UNITED STATES PATENT AND TRADEMARK OFFICE

APPLICATION NO.	FILING DATE	FIRST NAMED INVENTOR	ATTORNEY DOCKET NO.	CONFIRMATION NO.
10/711,593	09/28/2004	Mark D. Fairchild	P04-01	5592
25759	7590	01/26/2007		
JOHN J. ELNITSKI, JR. 225 A SNOWBIRD LANE BELLEFONTE, PA 16823			EXAMINER LEE, BENJAMIN P	
			ART UNIT	PAPER NUMBER
			3641

Office Action Summary	Application No. 10/711,593	Applicant(s) FAIRCHILD, MARK D.	
	Examiner Benjamin P. Lee	Art Unit 3641

Fig. 1.*Fig. 2.**Fig. 3.*

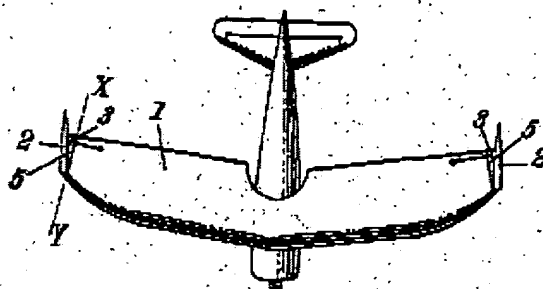
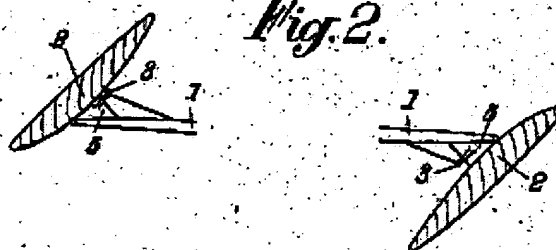
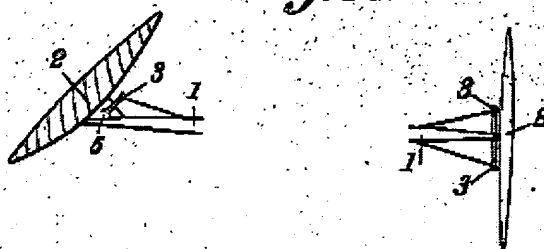
6. In regards to claim 1, Richard et al disclose a method of controlling an aircraft in a turn without the use of a rudder by producing induced yaw, comprising creating a net induced drag differential between an inboard wing to the turn and an outboard wing to the turn, whereby the net induced drag differential overcomes adverse yaw produced by the outboard wing (col. 1, lines 18-53). Note that Richard et al disclose manipulating "end-plates" on each wing to induce yaw. Although these "end-plates" do not necessarily increase the effective aspect ratio of the wings, they do create a moment force via an induced drag differential between the inboard and outboard wings. The induced drag is an inherent consequence of allowing stronger wing-tip vortices to form from the bottom of the inboard wing to the top.

7. In regards to claim 2, Richard et al disclose that the net induced drag differential is produced by controlling the aircraft such that the induced drag experienced by the inboard wing is greater than the induced drag experienced by the outboard wing (see fig. 3 following). Note that the left (inboard) wing "end-plate" is pivoted and the right ("outboard") wing "end-plate" is in a "neutral" position. The pivoted "end-plate" induces greater drag than the "neutral" plate.

8. In regards to claim 4, Richard et al disclose spoiling a tip vortex on the outboard wing to reduce downwash coming off the outboard wing and reduce the induced drag experienced by the outboard wing; and increasing a tip vortex on the inboard wing to increase downwash coming off the inboard wing and increase the induced drag

experienced by the inboard wing (col. 1, lines 18-53). Note that the neutrally positioned "end-plate" on the right ("outboard") wing spoils or blocks the wingtip vortex reducing downwash and the pivoted "end-plate" on the left ("inboard") wing allows a wingtip vortex increasing downwash.

9. In regards to claims 6 and 8, Richard et al disclose providing adaptive control surfaces as part of the inboard and outboard wings to form a variable planform to affect the induced drag of each of the inboard and outboard wings and produce the net induced drag differential to overcome adverse yaw produced by the outboard wing (see fig. 3 following). Although figure 3 is a frontal view of the plane, it is clear and inherent that the manipulation of the "end-plates" constitutes a variable planform. As previously stated, the manipulation of the "end-plates" induces the drag differential.
